寄件者: December Huang <[REDACTED]>
寄件日期: 2025年09月23日星期二 12:14
收件者: Cheryl Tsz Man TSANG/PLAND
主旨: Re: A/NE-MKT/52 — Proposed Temporary Open Storage of Construction Materials with Ancillary Office (3 Years)
附件: QMP-01_Queue_Parking_Management_Plan.docx; GEO-MS-01
_Remedial_Reinstatement_Method_Statement.docx; PSP-01
_Pedestrian_Safety_Management_Plan (1).docx; TSA-01_Tree_Survey_and_AMS.docx; IMG_7705.pdf
類別: Internet Email

Response to Departmental Comments

| June 2025 | <p>Layout Plan</p> <p>Proposed Temporary Open Storage of Construction Materials with Ancillary Office for a Period of Three years at Lot 751 S.B RP in D.D. 82, Man Kam To, New Territories</p> | YING SHING (HOPEWELL) ENGINEERING CO.LTD. |

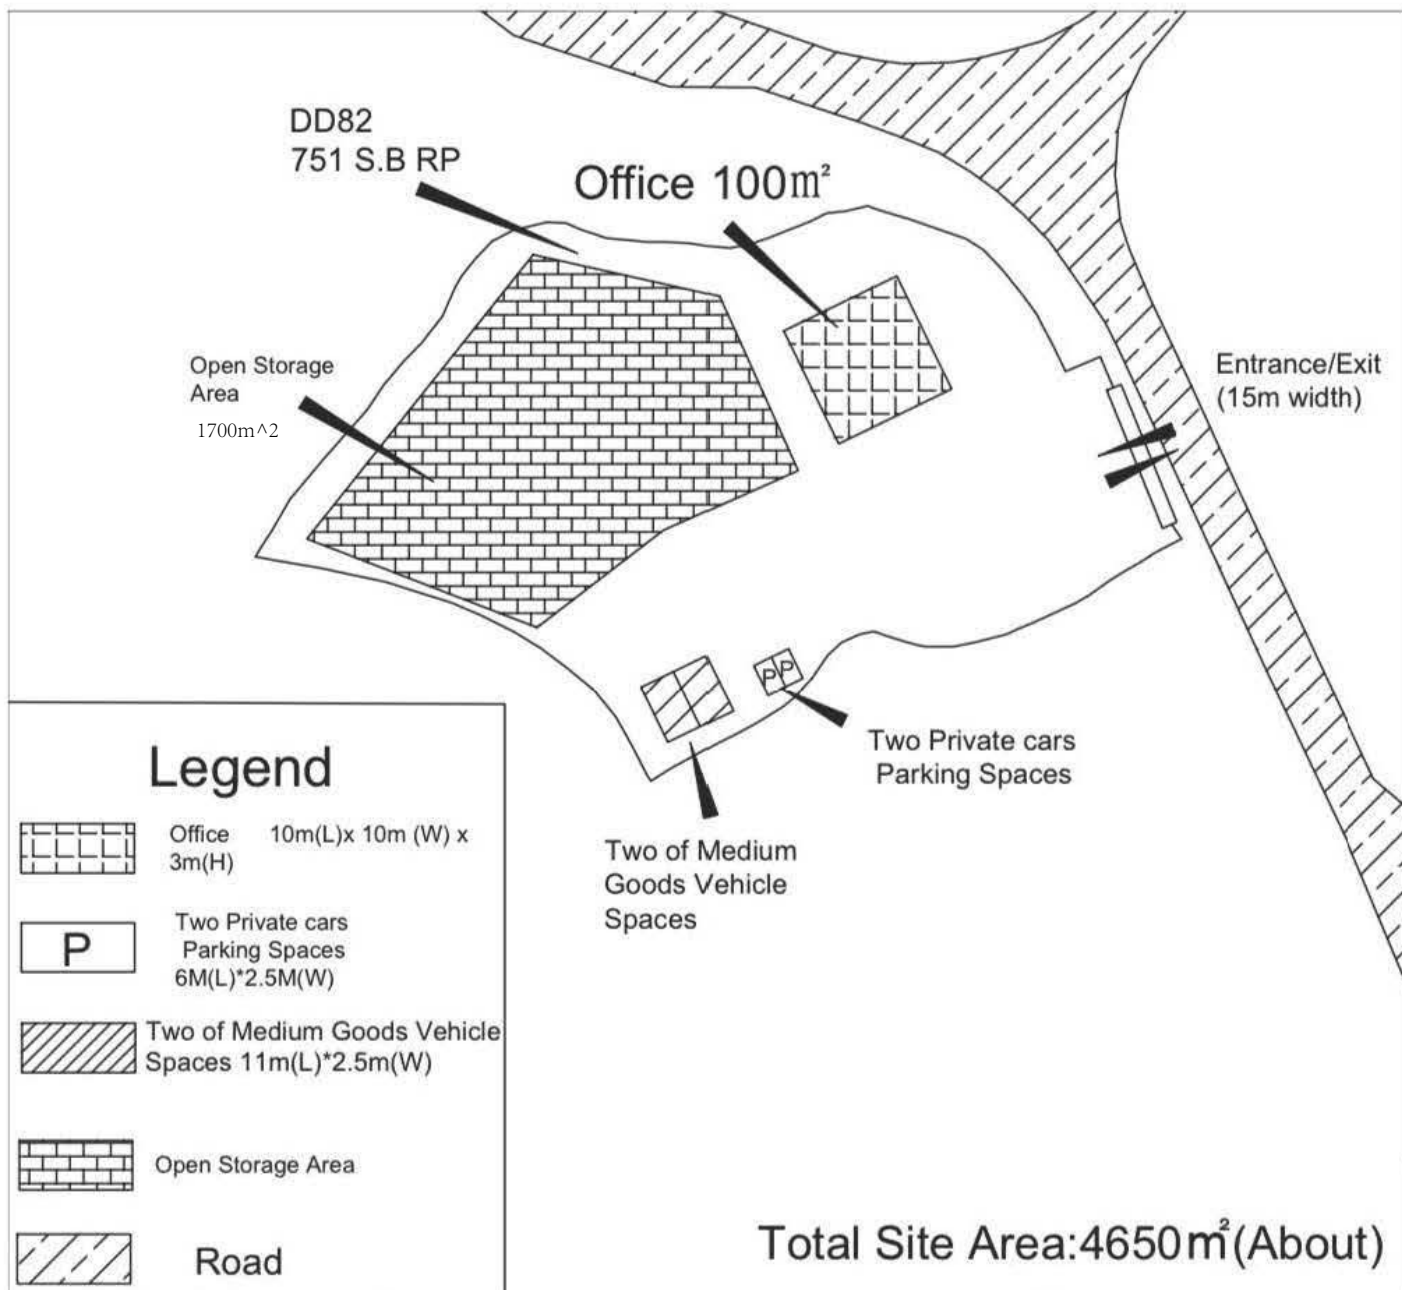
(i) Layout plan to specify storage area, amenity/supporting facilities and parking

- **Action:** A **Layout Plan** is enclosed, delineating:
 - Open storage zones
 - Ancillary office and welfare area;
